## ADDENDUM

<b>ADDENDUM #</b>
<b>02</b>

<b>ISSUED BY</b>	Brittany Bauer (Wilkus Architects)		
<b>PROJECT</b>	Mellette Community Center		
<b>ISSUED ON</b>	10/18/18	<b>REGARDING CONSTRUCTION DOCUMENTS DATED</b>	08/13/18
<b>ISSUED TO</b>	Bidders List

Addendum No. ME-1  
To Mechanical & Electrical Plans and Specifications:  
**Mellette Community Center**  
**Mellette, South Dakota**

**EAST / WEST BUILDING SECTION - (THRU RAISED PLATFORM)**

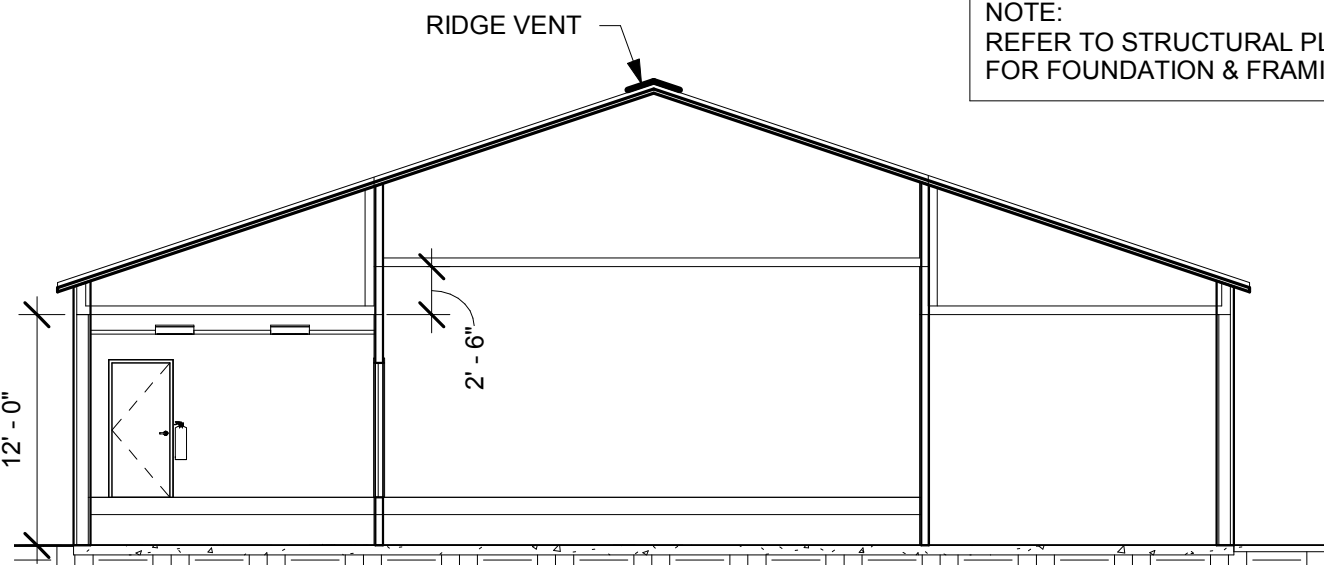
<b>ITEM</b>	<b>REVISION</b>		<b>REQUESTED BY</b>	Bidders
2	<b>CLARIFICATION</b>	X		
<b>DESCRIPTION:</b> Bottom of truss dimensions as shown on attached exhibit.
